**Marion County  
Board of County Commissioners**

**PLANNING & ZONING SECTION  
STAFF REPORT**

<b>P&amp;ZC Date: 03/25/2024</b>	<b>BCC Date: 04/17/2024</b>
<b>Case Number:</b>	240409ZC
<b>CDP-AR:</b>	31112
<b>Type of Case:</b>	<b>Rezoning</b> , modification of an existing PUD from Multi-Family units to a lower number of Single-Family units.
<b>Owner</b>	Sabana Farms LLC
<b>Applicant</b>	Tillman and Associates Engineering, LLC
<b>Street Address</b>	3718 NW 44th Ave, Ocala, FL 34482
<b>Parcel Number</b>	13709-001-00 (Portion)
<b>Property Size</b>	± 47.8 acres
<b>Future Land Use</b>	High Residential (HR), 4-8 dwelling units per acre
<b>Zoning Classification</b>	Planned Unit Development (PUD)
<b>Overlay Zone/Scenic Area</b>	Urban Growth Boundary and Secondary Springs Protection Zone
<b>Staff Recommendation</b>	<b>Approval with Conditions</b>
<b>P&amp;ZC Recommendation</b>	<b>Approval with Conditions</b>
<b>Project Planner</b>	Marcus Lloyd
<b>Related Case(s)</b>	22-S10 (MR to HR FLU), 220512Z (Rezoning to PUD to allow for 282 townhomes)

**Figure 2**  
**Conceptual Plan**

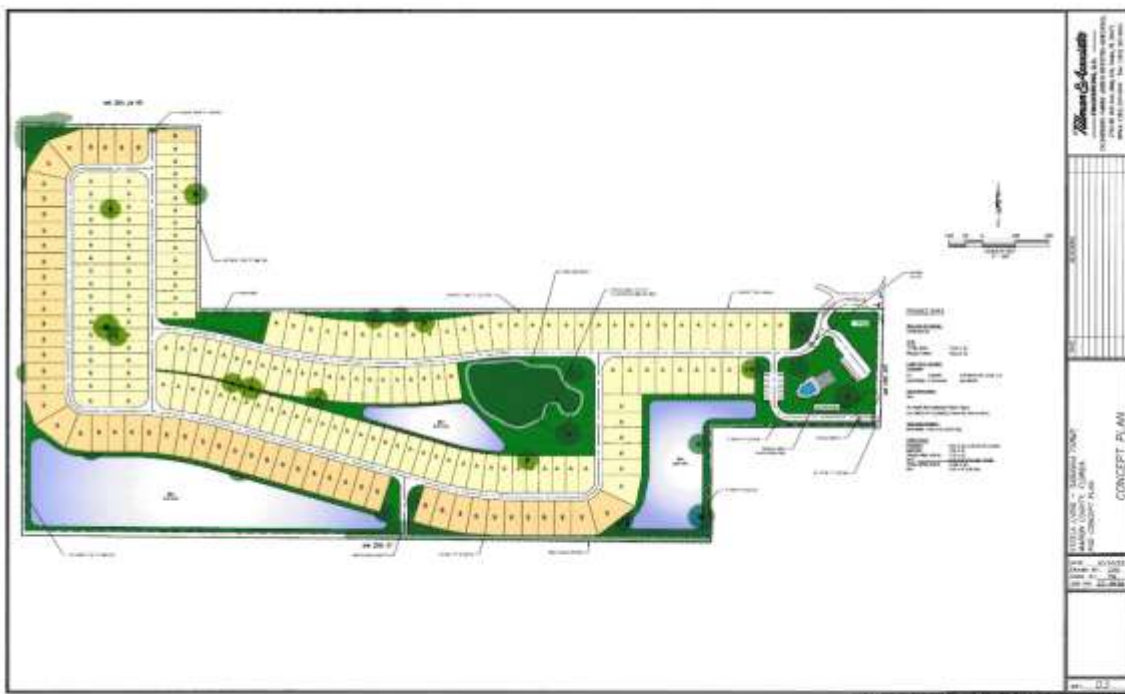
**Analysis:** Buffer details are proposed within the application (see Attachment A, Page 19). Staff finds that the PUD is proposing a 15' C-type buffer along the ROW on NW 44th Ave and on the southernmost boundary. This will also include tree preservation incorporated into the C-type buffer on the south. Along the west property line the conceptual plan proposes a modified 10' ft C-type buffer. Along NW 35th LN RD and the northwestern boundary of the PUD, a 10' modified C-type buffer is also proposed. On the Southeastern boundaries of the PUD adjoining a County DRA, a 5' E-type buffer is proposed. Each of the C-type buffers shall contain two shade trees and three understory trees per every 100' lineal feet, or as modified for the specific buffers proposed in the concept plan. Shrubs and groundcovers, excluding turfgrass, shall comprise at least 50 percent of the required buffer and form a layered landscape screen with a minimum height of three feet achieved within one year. The E-type buffer includes four shade trees per every 100 lineal feet, and shrubs that meet ground coverage requirements. Shrubs shall be planted in a double-staggered row and reach a maintained height of six feet in three yrs. Notwithstanding, staff recommends the following condition be imposed:

**Analysis:** Access to the property is shown on the conceptual plan. There are two gated access points to the PUD from NW 44th Ave, with one of the gates to the north being after entrants would reach a common parking area that is external to the pool area (See Attachment A, page 20). An emergency access point on NW 35th St. is also proposed for first responders. All roads as part of this PUD will be paved. Notwithstanding, staff recommends the following conditions are imposed:

**Analysis:** Staff finds the PUD proposes sidewalks along the adjacent rights-of-way and on at least one side of all internal roads. There is also an integrated trail system through the PUD that is incorporated into the open space provided to residents. However, there are no multimodal facilities shown on the conceptual plan. Sidewalks along all unnamed roads shall be provided connecting the PUD and all adjacent land uses. During the staff site visit, staff observed the sidewalks in the adjacent PUD to the north were used by bicyclists and pedestrians, and golf carts were driven on the internal roads. Staff recommends the following conditions be imposed:

**Analysis:** Staff finds the PUD proposes sidewalks along the adjacent rights-of-way and on at least one side of all internal roads. However, multimodal circulation is not shown within the conceptual plan, but could be done so with local roadway connections for bicyclists and golf carts. There are no bus stops shown within the application. Staff recommends the following condition be imposed:

**Analysis:** Staff finds the PUD provides parking calculations for community uses. The concept plan proposes two separate parking areas for the common amenities area, one internal and one area that is external. The number of parking stalls has not yet been calculated. LDC requires 1.5 parking spaces for each residential unit. Notwithstanding, the following condition is imposed:

- *Buffers shall be provided as shown on the submitted conceptual plan. ~~In order to be in compliance with the LDC, a waiver must be granted for the 10' modified C-type buffer; this request must be~~*

- *Show pedestrian connections from PUD area to all adjacent land uses on the project plans.*

- *Show sidewalks along at least one side of all internal roads and connections to multimodal paths.*
